BID ADDENDUM NO. 1 COVER SHEET

RE: Ramapo College of New Jersey
H-Wing 2nd Floor – Les Paul Studio
RCNJ Project No. 2014-02-01C

**ADDENDUM NO.1
Dated February 27, 2015**

DEMOLITION PLAN
AND REFLECTED
CEILING PLAN

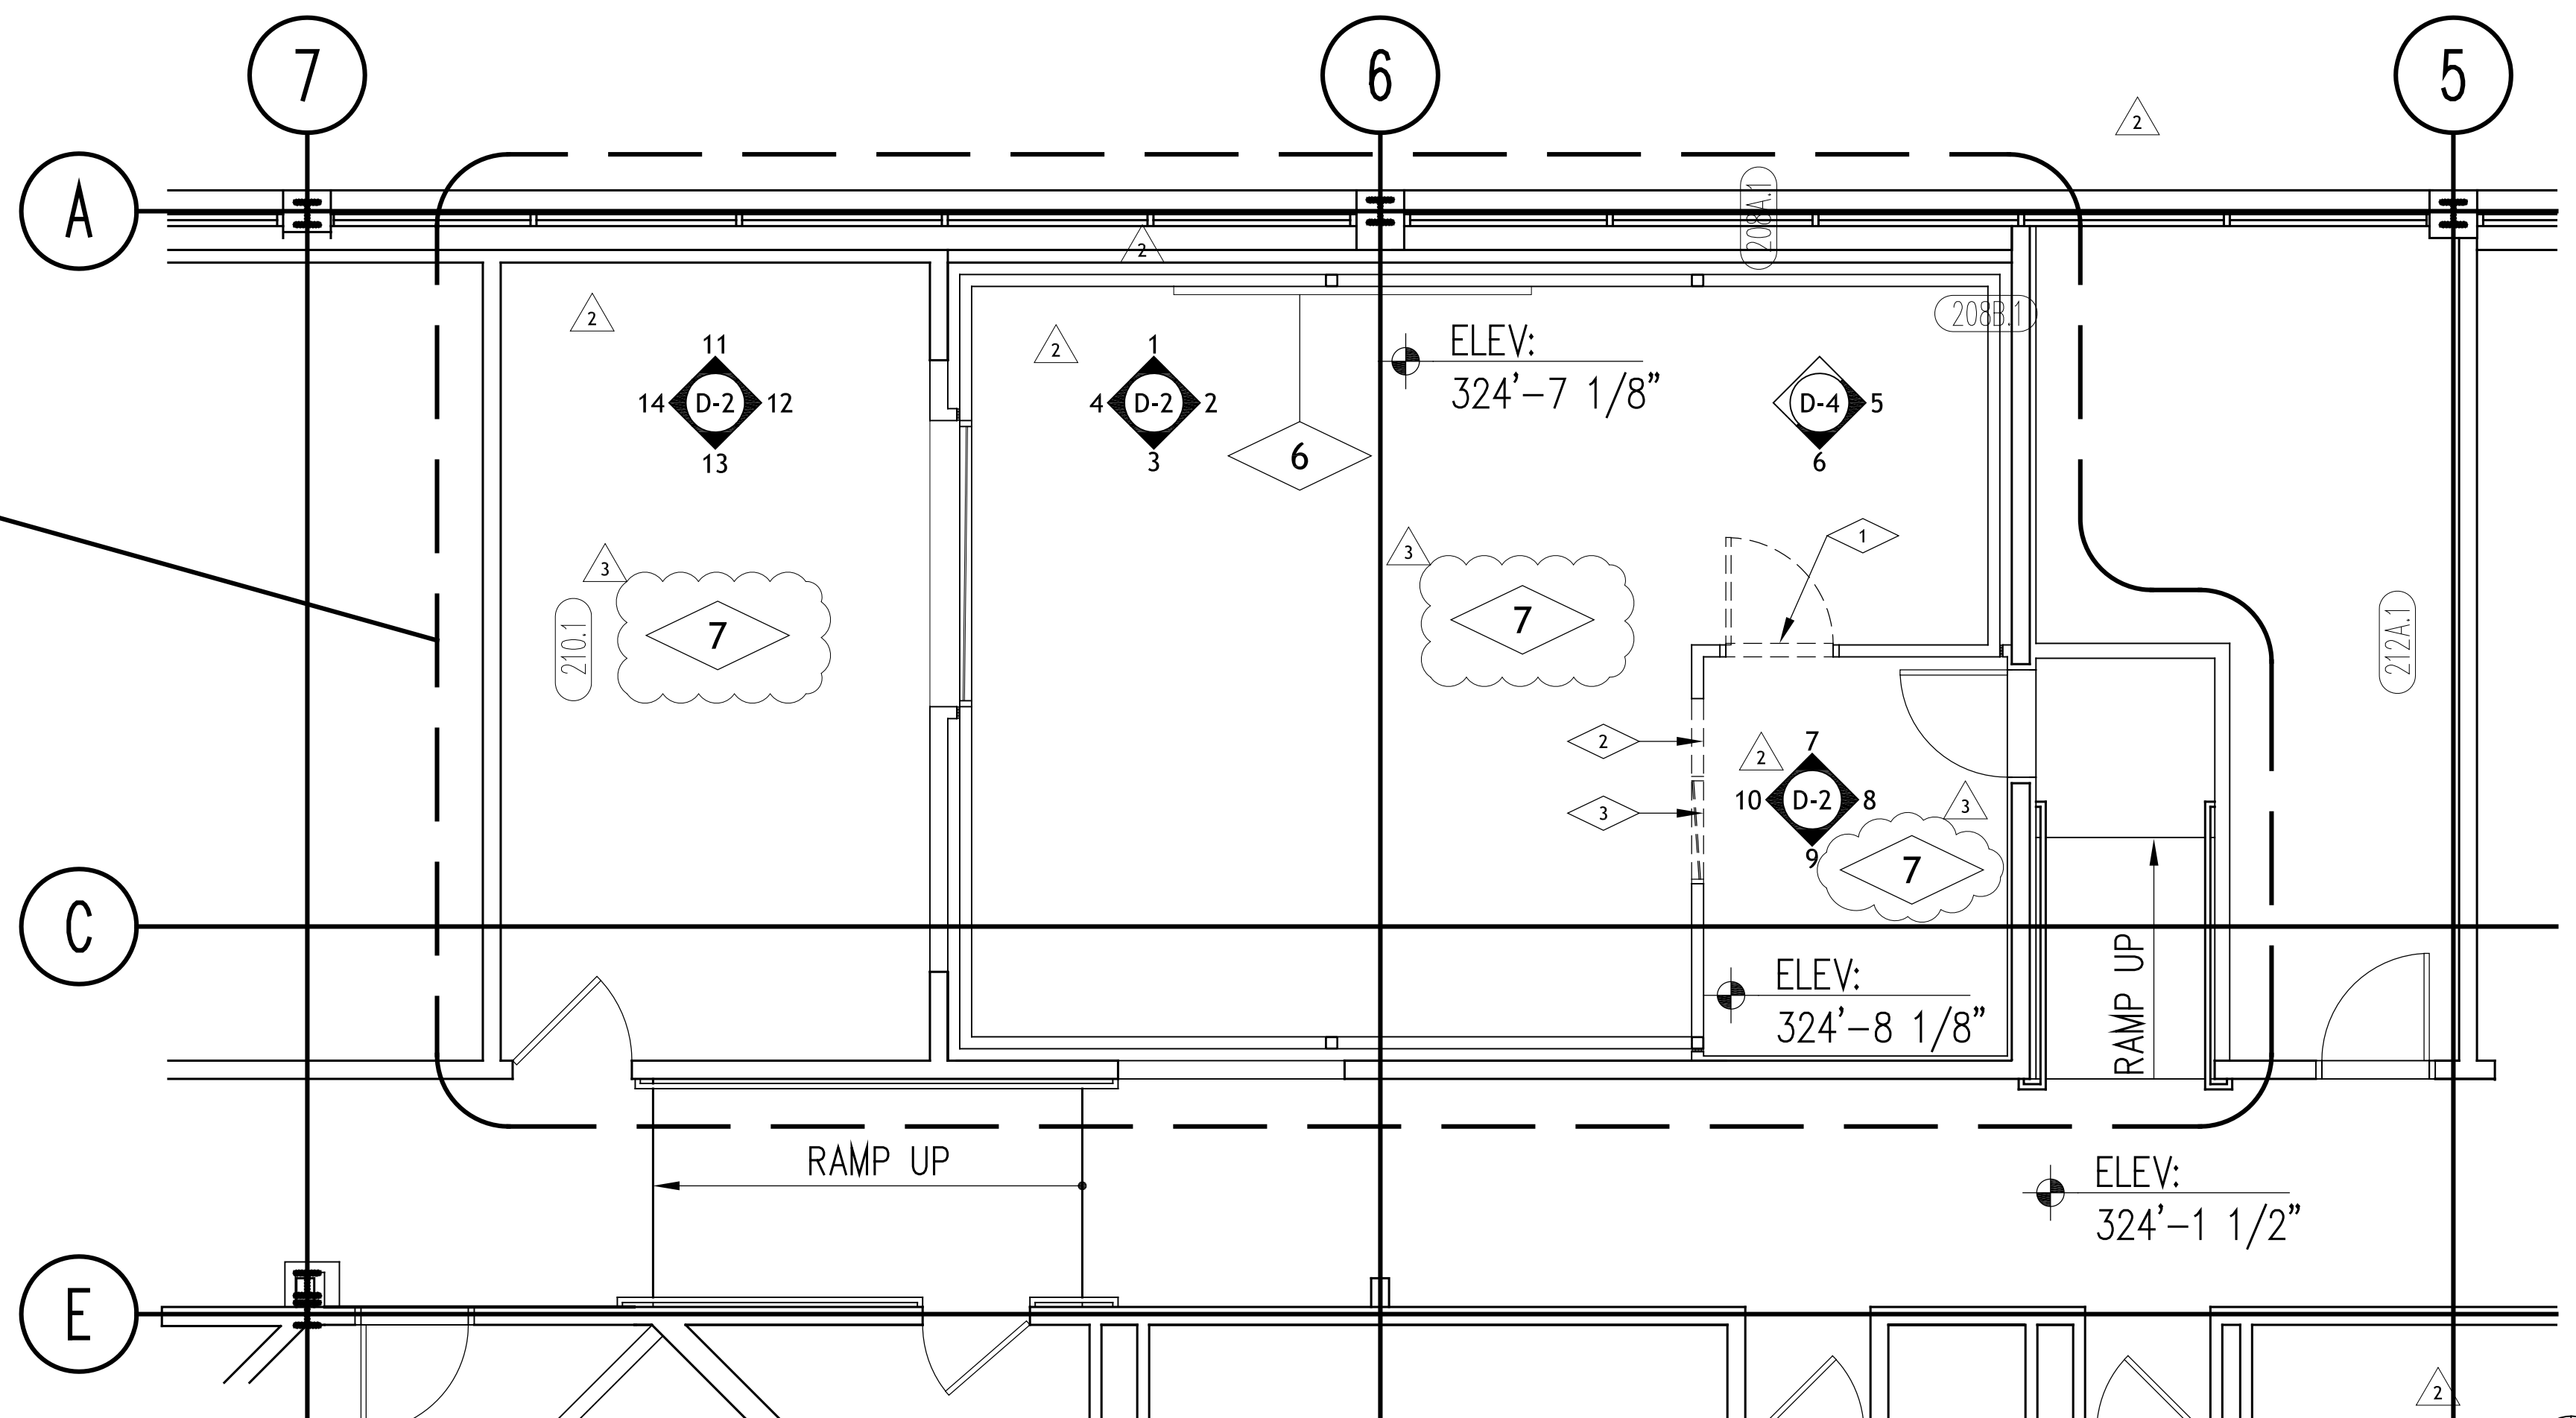
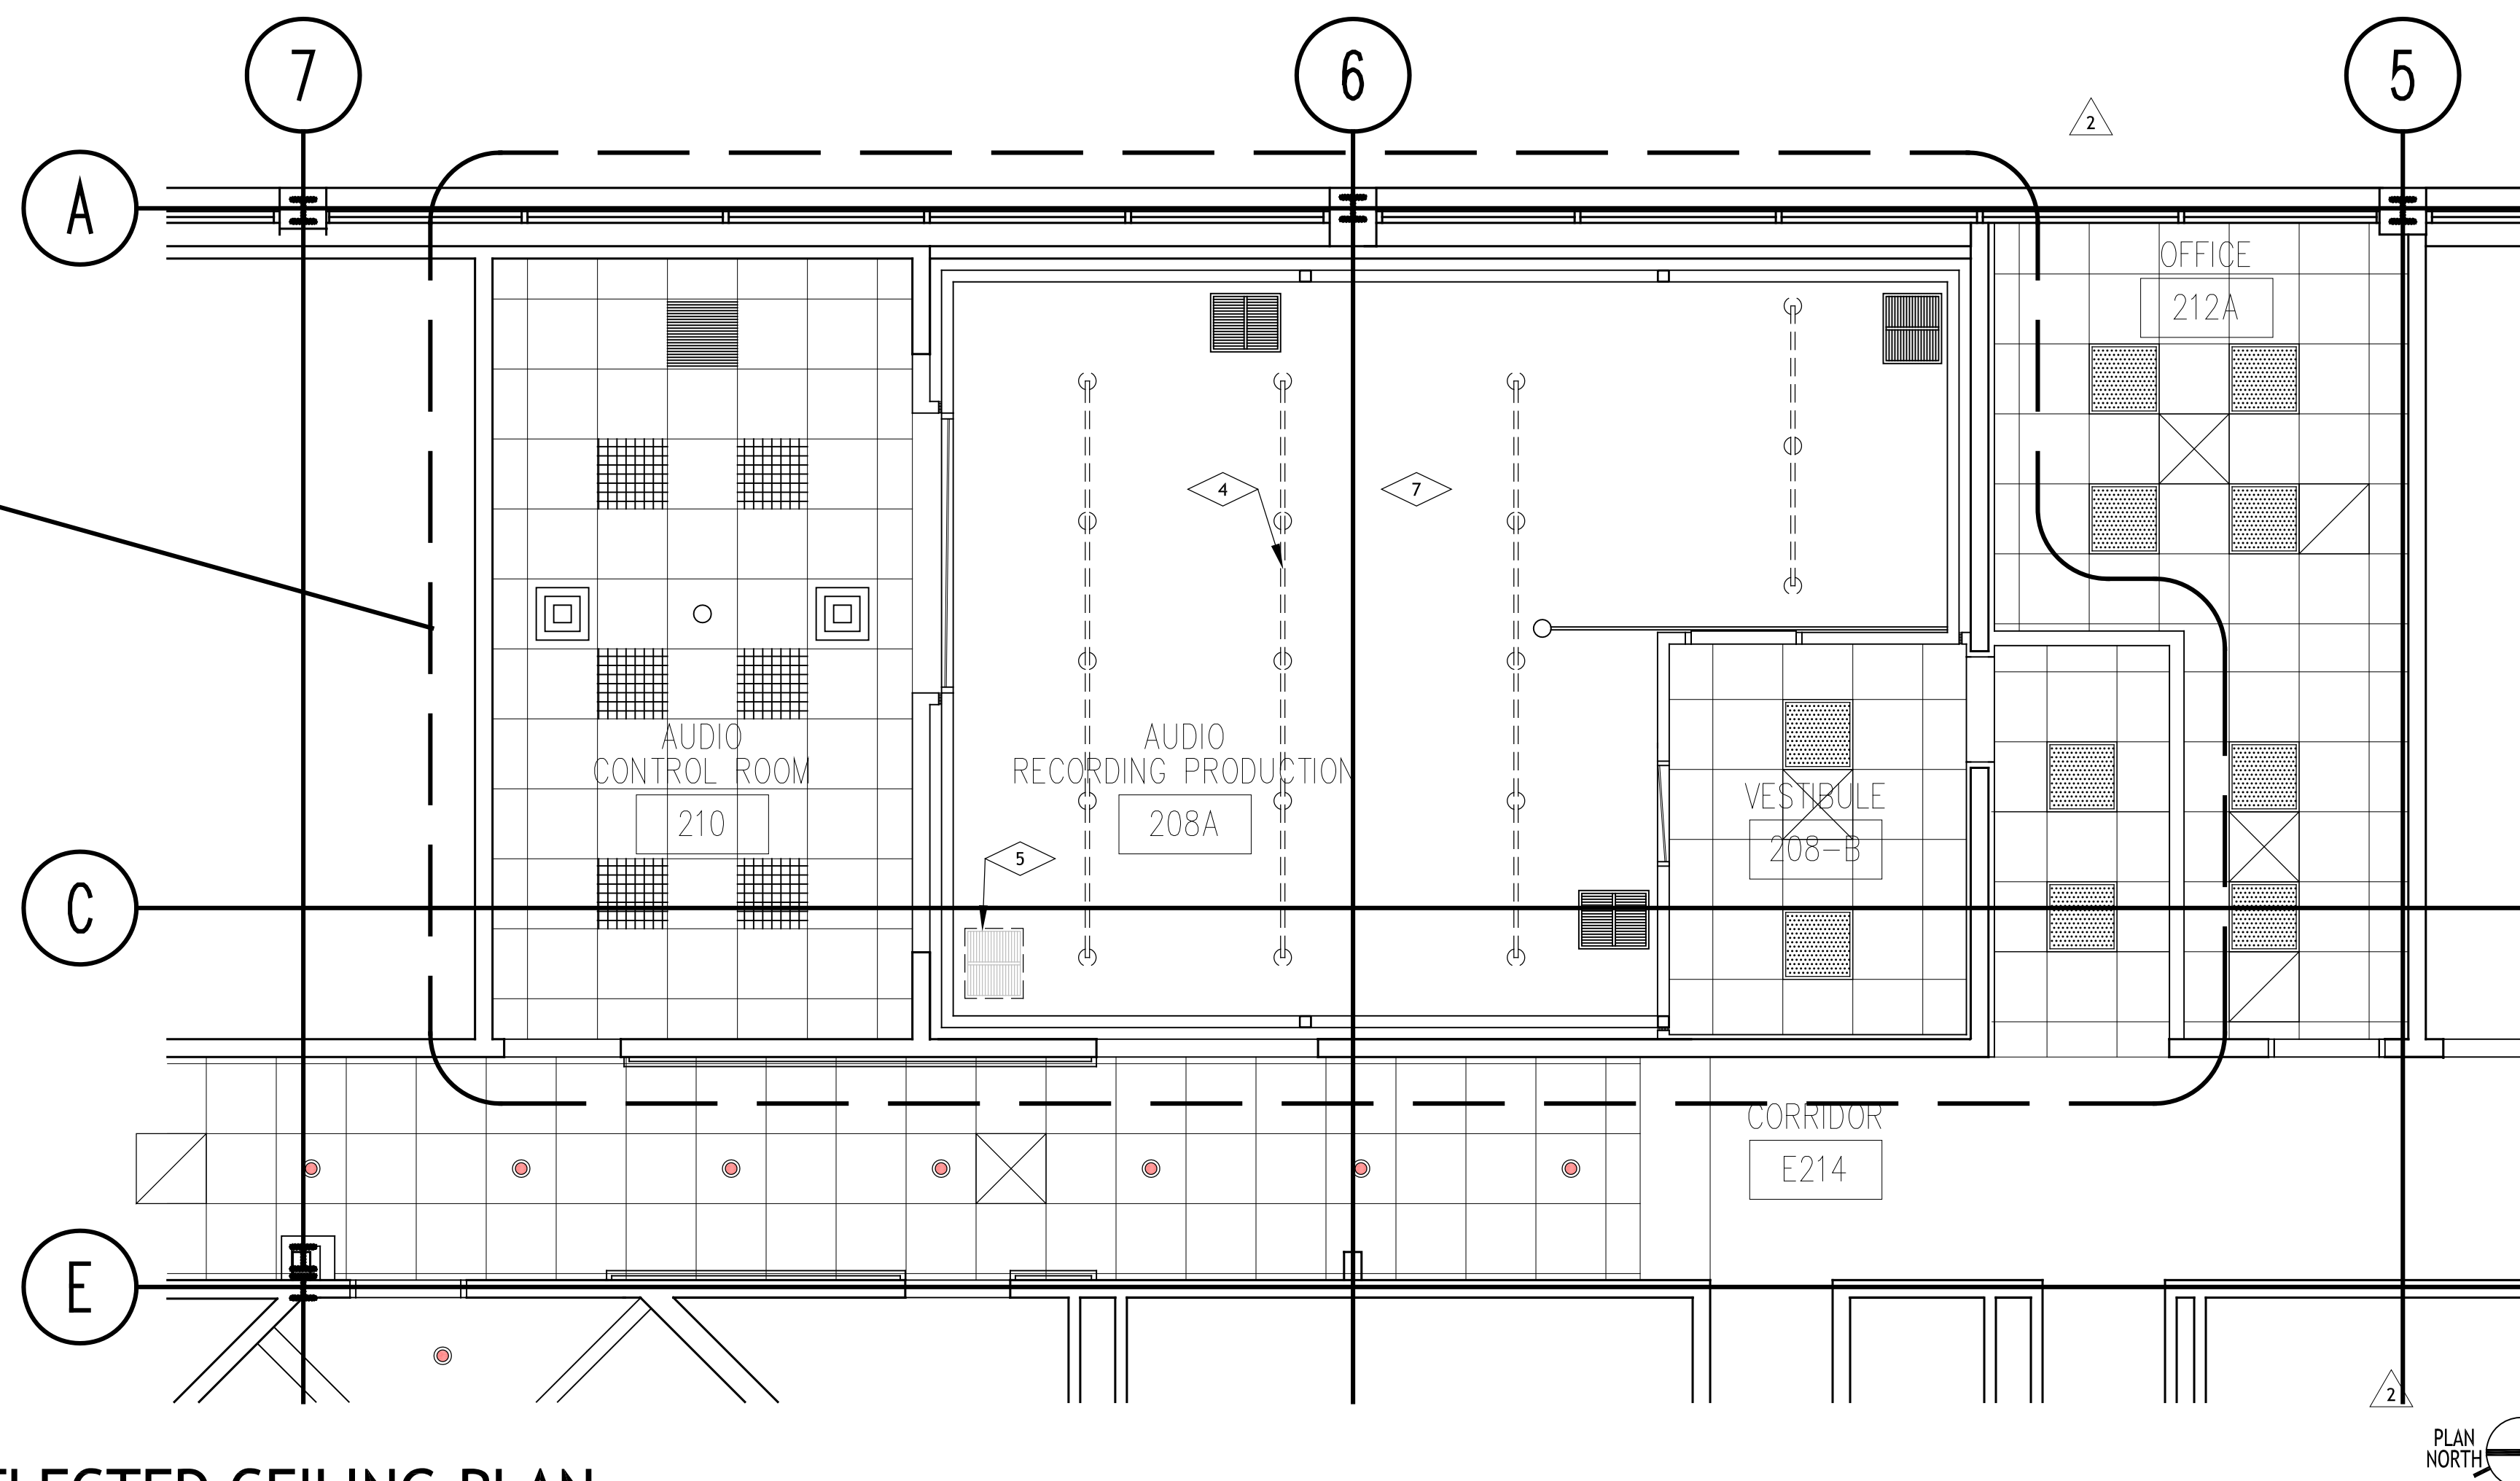
III-1 The D-1 and D-2 drawings don't show any removal of the existing floor finishes in room 208A and 208B. Room 208A has existing VCT tiles that are in rough shape, and the subfloor appears to be damaged.

III-3 Room 208B has a top layer of carpet. What is the scope of work regarding the preparation for the new floors, for the base bid?

Response: The scope of the project is to include removal of existing finished flooring in Rooms 208A and 208B. Scope is to include repairing of the subfloor as needed to ensure a good

installation of the specified flooring. See the revised Sheet D-1 which is re-issued as part of this addendum. The revised Sheet D-1 is attached.

Response: *Carpet and any other finished flooring is to be removed. The subfloor is to be prepared as stipulated by the manufacturer of the specified flooring that is to be installed. See the revised Sheet D-1 which is re-issued as part of this addendum. The revised Sheet D-1 is attached.*

- 1 REMOVE EXISTING DOOR, FRAME, AND HARDWARE. INFILL EXISTING R.O. TO MATCH ADJACENT PARTITION CONSTRUCTION. SEE ELECTRICAL DRAWINGS FOR ADDITIONAL INFORMATION. SAVE AND STORE DOOR, FRAME, AND ALL ASSOCIATED HARDWARE FOR REINSTALLATION.
- 2 REMOVE EXISTING PARTITION CONSTRUCTION AND FRAMING TO EXPAND R.O. FOR REINSTALLATION OF DOOR.
- 3 REMOVE EXISTING WINDOW, PARTITION CONSTRUCTION AND FRAMING TO EXPAND R.O. FOR REINSTALLATION OF DOOR.
- 4 REMOVE EXISTING TRACK LIGHTING FIXTURES AND TURN OVER TO THE OWNER.
- 5 REMOVE EXISTING SUPPLY AIR GRILLE AND SAVE FOR REINSTALLATION. SEE MECHANICAL DRAWINGS FOR ADDITIONAL INFORMATION.
- 6 REMOVE EXISTING WHITE BOARD.
- 7 REMOVE ALL EXISTING FLOORING AND PREPARE SUBFLOOR FOR NEW FLOOR FINISH.

15 RM 210 WEST EL
SCALE: 1/4"=1'-0"

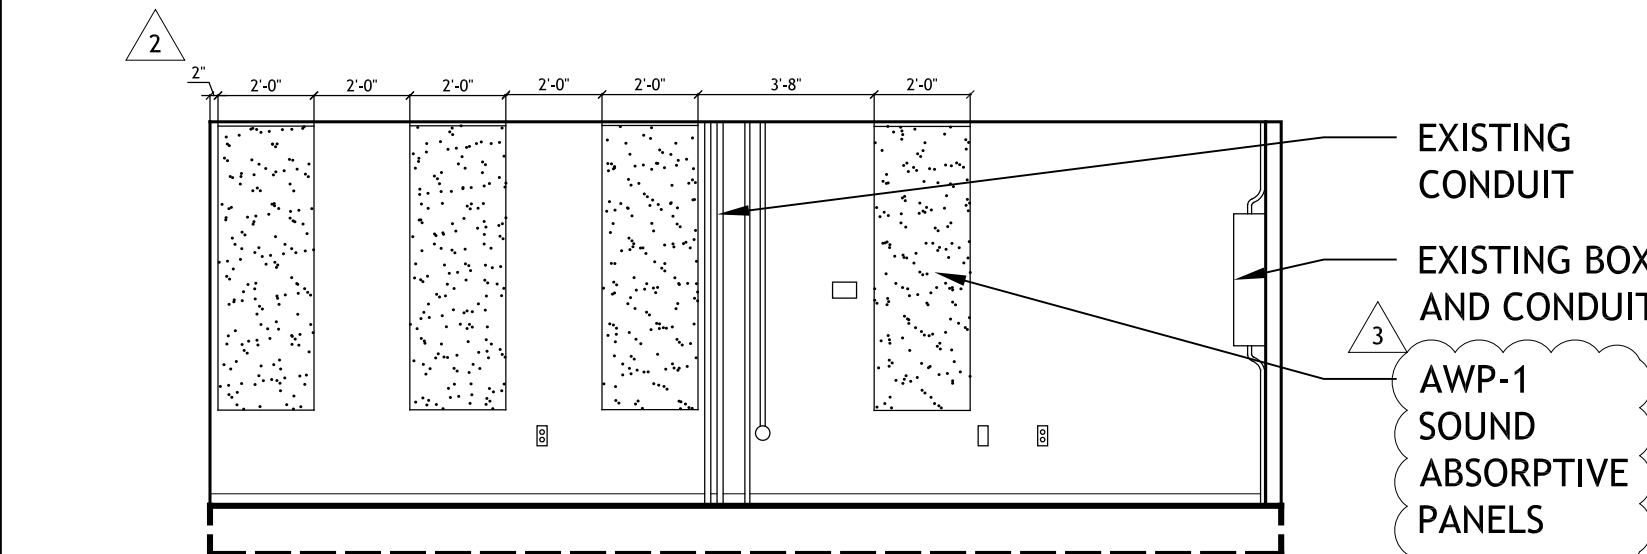
IV-3 Drawings A-3 /15 RM 210 west elevation show the Acoustical diffuser 6'x4'. Spec section 09 84 13 /2.3 Absorptive-Diffusive panels "C. Panels to be provided wrapped in specified fabric". Does that mean to be provided by owner and wrapped by contractor like the other Acoustical panels?

Response: *The absorptive-diffusive panels (AWP-2) are to be provided by the General Contractor wrapped in the specified fabric the Scope of Work. Specification section 09 84 13 Acoustical Wall Panels has been revised and the section is issued as part of this Addendum*
